SCOPING OPINION:

Proposed Botley West Solar Farm

Case Reference: EN010145

24 July 2023

Figure 1
 showing 'Botley West' in dark blue, the most likely alternate location of the 440kV National Grid substation in light blue, and the perimeter of the proposed Red House Farm solar power station in red

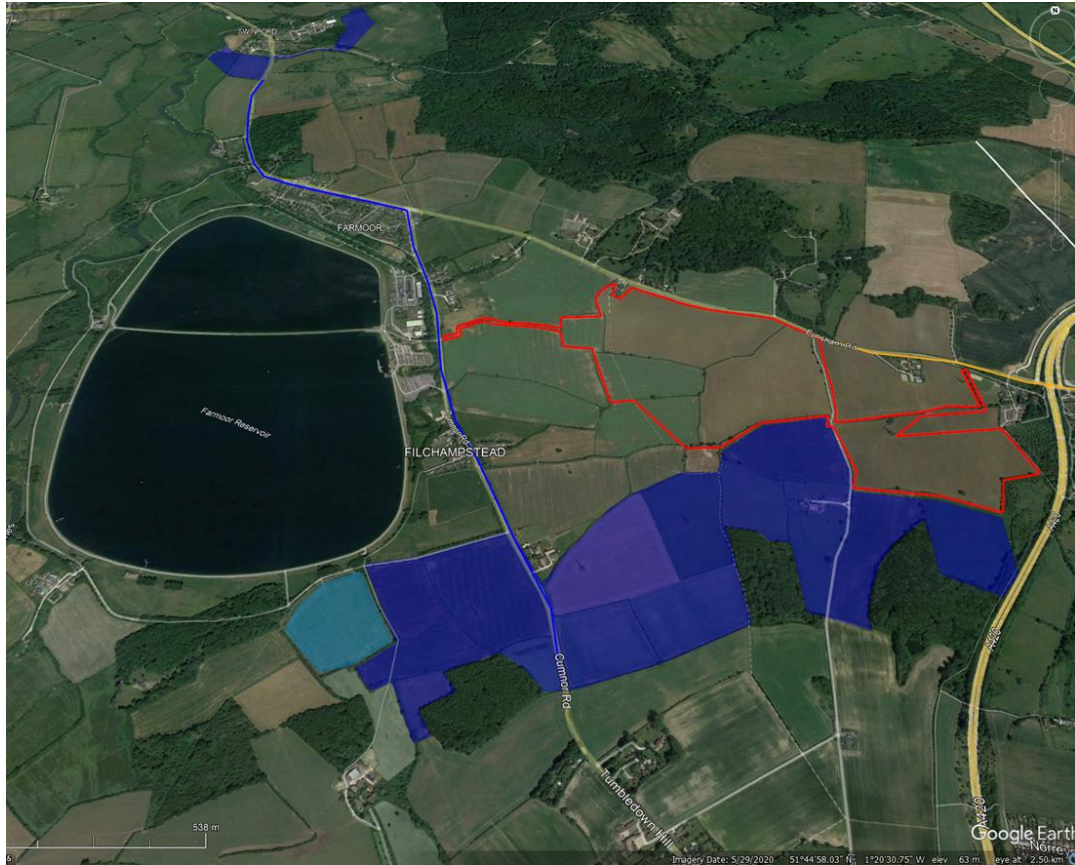
Council draws PINS attention to the fact that the proposed southern site lies immediately adjacent to, and south of, another proposed solar power station (Red House Farm – see Figure 1 below) where the Vale of White Horse District Council (VWHDC) has required an extensive set of Environmental Impact Assessments be carried out ([P22/V2581/SCO](#)).

Figure 2

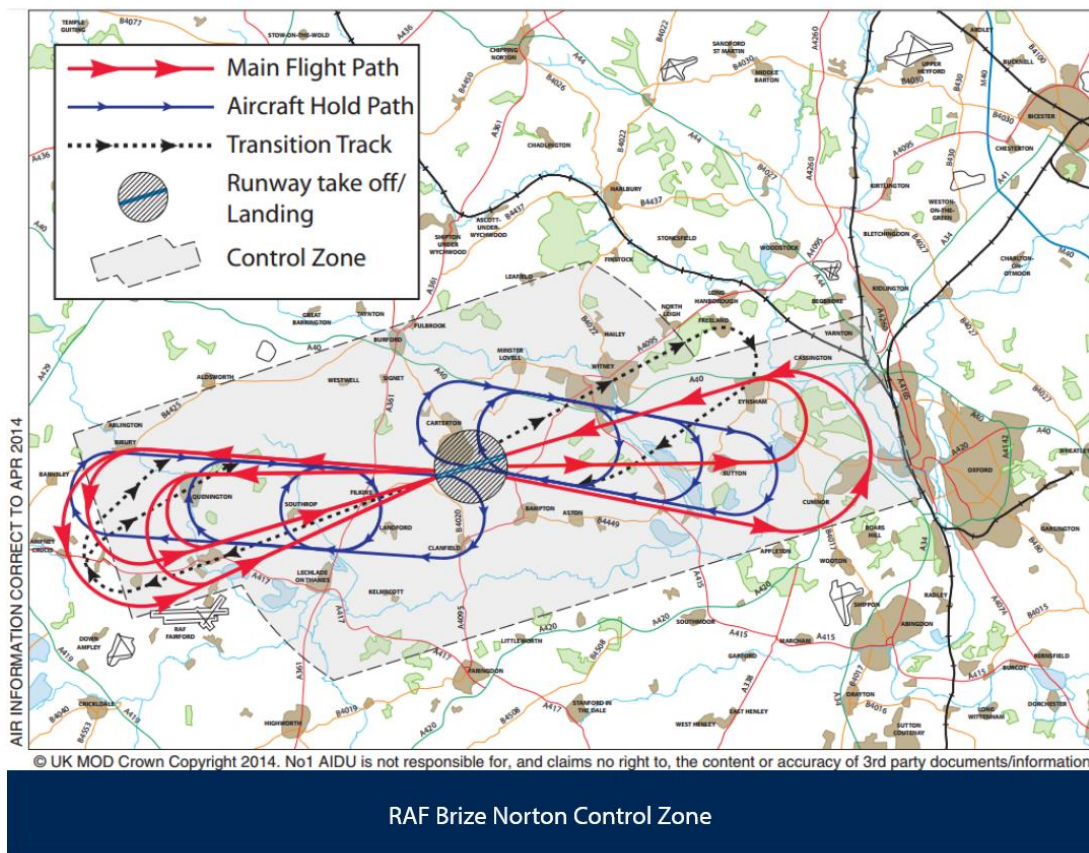
Council requests that RAF Brize Norton (to the west of the central and southern sections, with the southern section being on the designated flightpath) should be included (para 8.3.14) – see also Figure 2 below.

Recent, well publicised fires in solar power stations in the UK and overseas point to the necessity of applying the precautionary principle here, particularly as the site is just a km or so to the west of Oxford and will be within 60m of Thames Water's Farmoor reservoir (14 million litres, supplying Swindon etc.), and which lies directly under the RAF's flight path, and within the Control Zone, for RAF Brize Norton (see [Figure 2](#) below).
